Access Compliance Report

Public Rights-of-Way

(Curb Ramps)

| Intersection ID: 26629 | Main Street: ALPINE_FOREST_CT | Cross Street: MANOR_HOUSE_DR | Location: NW |

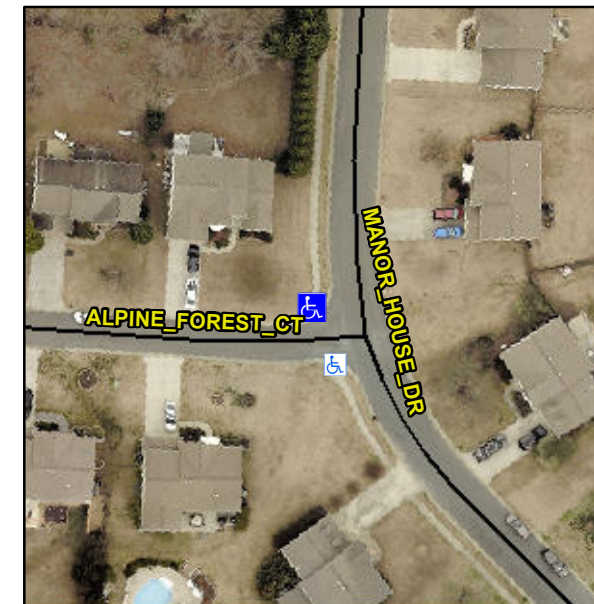
| ADA ID: A3CC7A138614 | Ramp Type: Perp | Initial Pass/Fail: Fail | Overall Compliance: No |

Not Found, R304.5.3

| Compliance | Description | Data | Compliance | Description | Data |
|------------|-----------------------|------|------------|-----------------------------|------|
| Yes | Ramp Width (in) | 48.0 | No | Ramp XSlope (%) | 3.6 |

Remove & Replace Entire Ramp.
